# COMMUNITY ENGAGEMENT SUMMARY REPORT

Montgomery Reserve Playground Proposal  
Stage 2: Design

## APPENDIX A - MONTGOMERY RESERVE PLAYGROUND DESIGN CONSULTATION COMMENTS SUBMISSIONS

**MONTGOMERY RESERVE  
FLINDERS PARK  
NEW PLAYGROUND CONCEPT PLAN**

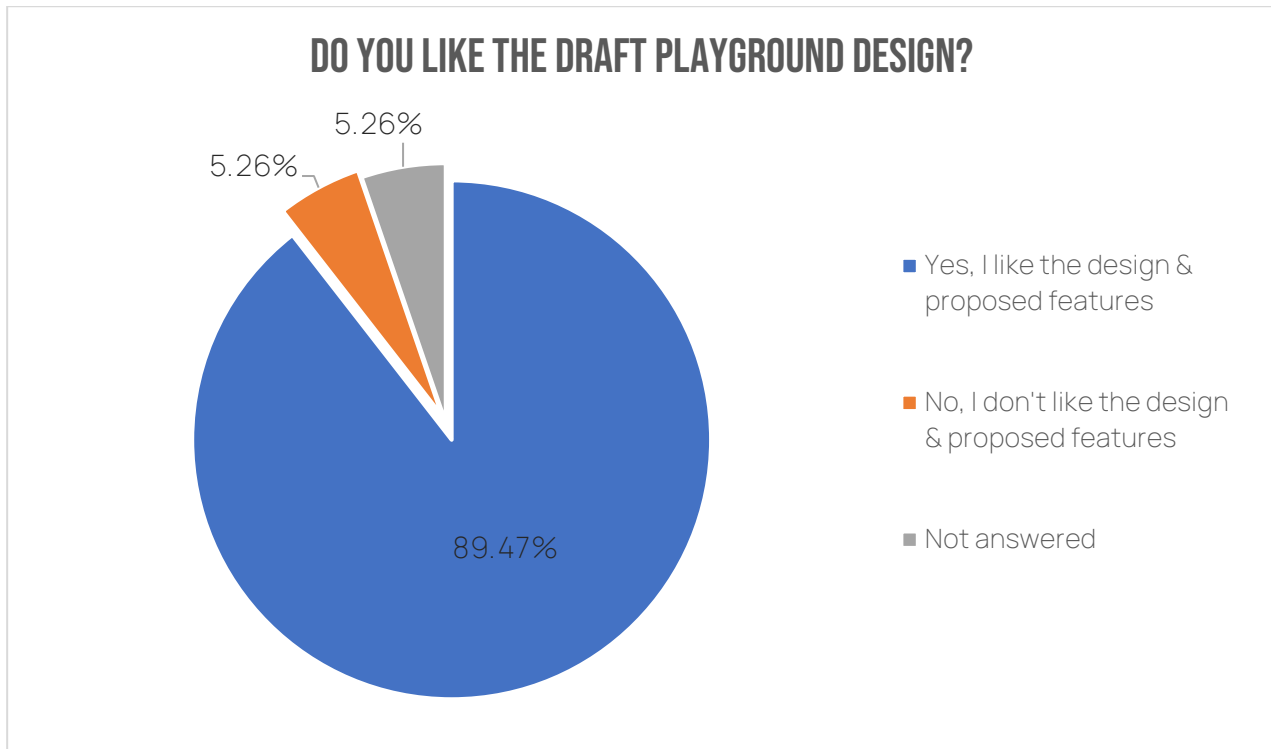
Ref	Feedback Form Comments	Staff Response
1	I like the nature play, keeping the area more natural.	Comment noted.
2	We like the nature play and seating. We like the trampolines. We would like the inclusion of a slide and a zipline (from my 6 year old). My husband would like a basketball ring.	A slide and flying fox have not been included, due to the available space, cost, and proximity of these features in other playgrounds, including John Keeley Reserve located 500 metres from Montgomery Reserve. There were a low number of requests for a slide, and in addition, these items are included at other nearby reserves. A basketball court/ring is also not recommended due to the close proximity of other courts at Ross Reserve (800m) and River Park Reserve (1km). The proximity to residents (20 metres) is also a consideration. A basketball ring could be considered at Flinders Park Oval in the future.
3	Remove Music Play Remove understory planting and tree planting and replace with community veggie garden (keep irrigation). Add flying fox.	Quieter' musical instruments are proposed in the final design. A community garden is not proposed at this stage, as these require a high level of input from council staff and ongoing support from the community. If you can demonstrate community support for a community garden where local community are happy to administer and maintain a garden, you can visit <a href="https://www.charlessturt.sa.gov.au/environment/sustainable-lifestyles/community-gardening/community-gardens">https://www.charlessturt.sa.gov.au/environment/sustainable-lifestyles/community-gardening/community-gardens</a> or contact Council's Open Space Community Planner to explore this further. Space and irrigation is available for future implementation. A flying fox is not proposed due to the available space, cost and proximity to the flying fox at John Keeley Reserve.

4	Seating we would prefer some as listed and a few that are now in parks with back support more comfortable flying fox are very popular.	Seating with a back rest has been included in the amended concept design.
5	I like the design & hope it encourages families to bring their young children to get out the house and enjoy the facility.	Comment noted.
6	We like the concept plan. Planting greenery , concrete path and mulched ground. I am very positive that kids will enjoy Swings and Trampoline. Seating bench is good as well for parents and grand-parents to sit and watch while kids are playing. We personally did not like the big stones/ nature play idea as we have personally experienced small kids falling and hurting them self on the sharp rough edges. <u>Overall we liked the plan.</u>	Comment noted. Logs and rocks will be engineered to ensure rough or sharp edges are minimised, similar to other playgrounds within the council area.

7	I'd prefer to have kept this space open however I'm glad there will be garden beds planted. Hopefully with a variety of plants native to the area? Also there are two recently planted trees in the space of the proposed playground, I'm hoping the council will be able to accomodate them into the design or <u>move them successfully.</u>	Native plants will be incorporated into the playground design. The existing juvenile trees will be incorporated into the design, or relocated to a more suitable location nearby.
8	I like: swings, log traverse, trampoline and hammocks what we would add: an exciting climbing feature, maybe a wooden structure to go with the theme. Maybe also a large sandpit (as per playground on greville). I'd also add a track around the playground for ride on vehicles. Thanks :) 08/03 - Phone call with this respondent follwed by an email submission, also suggested the following equipment: <ul style="list-style-type: none"> <li>Some kind of exciting climbing facility that is almost exciting/scary. Anything tall that they can climb (eg rope pyramid in the playground at South Terrace - enclosed picture of castle structure - refer <b>Appendix B</b>).</li> <li>Flying Fox (like at John Keeley reserve). It is a big hit and good for different ages. It's so low that it tailors to each child's age and ability.</li> <li>BIG slides</li> <li>Dry cleaners spinning rack that the kids can hang onto. Love that too.</li> </ul>	Comment noted. Ideas such as flying fox, climbing and spinning features are included at John Keeley Reserve and not recommended due to cost and available space. It is also noted that the playground at Flinders Park Oval (800m away) is recommended for renewal in 24/25, subject to Council approval.

9	I would like to see included a barbecue set up (cooktop, table & seats) and a toilet.	BBQ and toilet not proposed as these facilities are recommended at larger district and regional reserves. These facilities are also located at Ross Reserve (800m away), Tedder Reserve and River Park Reserve (both 1km away).
10	There is not "Slippery Dip" for the kids to slide down, in the current design.	A slippery dip has not been included, due to the available space, cost, and proximity of these features in other playgrounds, including John Keeley Reserve located 500 metres from Montgomery Reserve. In addition, only a small number of comments were received requesting a slide.
11	I do not feel the playground is required given there are other playgrounds in close proximity. I am also worried about how many mature trees will be removed to facilitate the playground. I think the grassed area is best left as it is.	Following consultation in September and October 2022 that found 72% of respondents support the proposal, Council has endorsed a second round of consultation on the draft design of the new playground. In addition, the project will have no impact on existing mature trees.

12	Music play may impact on close neighbours.	Comment noted.
13	Will be great for community members and families by the river. Good use of green belt	Quieter' instruments are proposed in the updated design. Similar instruments are installed at other locations around Adelaide. The example shown is from Bristow Smith Reserve, Goolwa.
14	Concise and inclusive	Comment noted.
15	I like the design proposed for the planned playground. We also hope that benches are provided for seating and weather any exercise equipment can be implemented that adults and children can use.	Comment noted.
16	I generally think the design is good and it is in the right location within the park. Might be nice to have some open grass area too for kicking a ball around. <u>Bit concerned about how loud the music play might be and if bigger kids will muck around with it at night.</u>	Comment noted. Fitness equipment is not included due to the proximity of fitness equipment at John Keeley Reserve. Fitness equipment may be included at Tedder Reserve in a future upgrade, subject to Council approval.

17	All activities are good	The design aims to retain large open areas within the reserve (for ball kicking, etc), both close to the playground, and to the west, adjacent to Wirringga Street. 'Quieter' musical instruments are proposed in the final design.
18	We like the nature play and natural feel of it.	Comment noted.
